SURFACE INSPECTION COMPLIANCE REPORT

Date of Inspection: <u>March 9, 1995</u>
Case Serial No.: UTU-063447
Operator: Jumbo Mining Company, Drum Mine
Project Description: Cyanide Heap Leach (Non-operational Status)
Legal Description: T. 15 S., R. 10 W., Section 7 (predominantly)
District and Resource Area: Richfield/HRRA
Inspector: Rody Cox, Wayne Hedberg, Tony Gallegos, Lynn Kunzler,
Tom Munson (UDOGM), and Dave Hartshorn (Jumbo)
REPORT NARRATIVE (REFERENCE STIPULATIONS BY NUMBER OR TITLE)

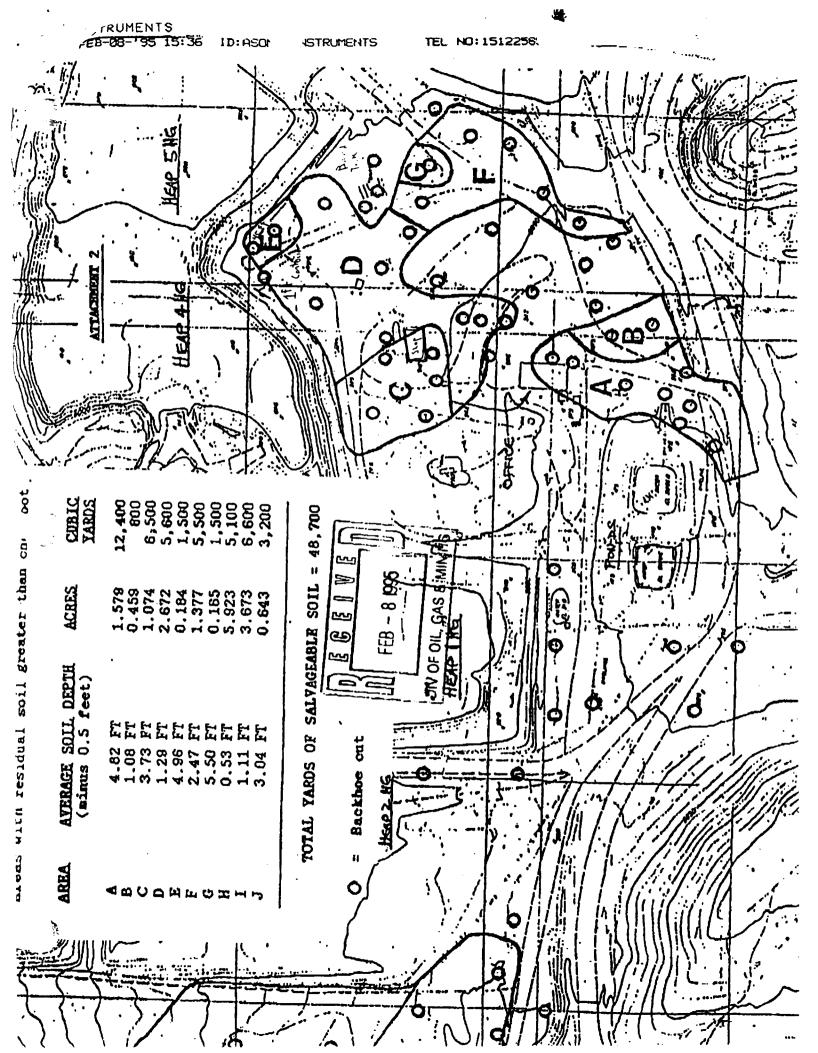
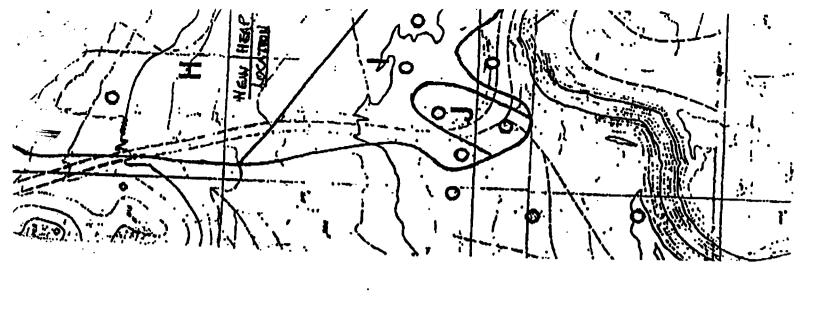
Attached is a copy of a map that shows the location of current topsoil stockpiles. Areas 1-6 are current topsoil stockpiles. The total volume of stockpiled topsoil present in areas 1-6 is approximately 8,500 cyds. The map also shows the locations of the trenches, areas proposed for topsoil salvage, the average estimated depth for each of these areas, the acres in each of these areas, and the cubic yards of top soil proposed for salvage associated with each of these areas. Areas A-J are the areas proposed for topsoil salvage. The total volume of topsoil proposed for salvage present in areas A-J is approximately 48,700. The combined total of topsoil would be approximately 57,200 cyds, which exceeds the amount currently required for reclamation (55,000 cyds).

This inspection confirmed that Jumbo's estimates appear reasonable. The "topsoil" is composed of multiple soil horizons and may not be as productive as just the "O" plus "A" horizons. Because these horizons comprise just a thin veneer at this location, Jumbo is justified in proposing to use augmented soil horizons for reclamation purposes. A soil analysis needs to be completed prior to allowing Jumbo to excavate and stockpile the proposed topsoil. It is recommended several analysis be done. At minimum one from each soil horizon and one composite sample from construction fill near the mill and/or process ponds. These analysis will help to identify any soil deficiencies, as well as amendments that may be used to increase productivity, hence facilitate reclamation.
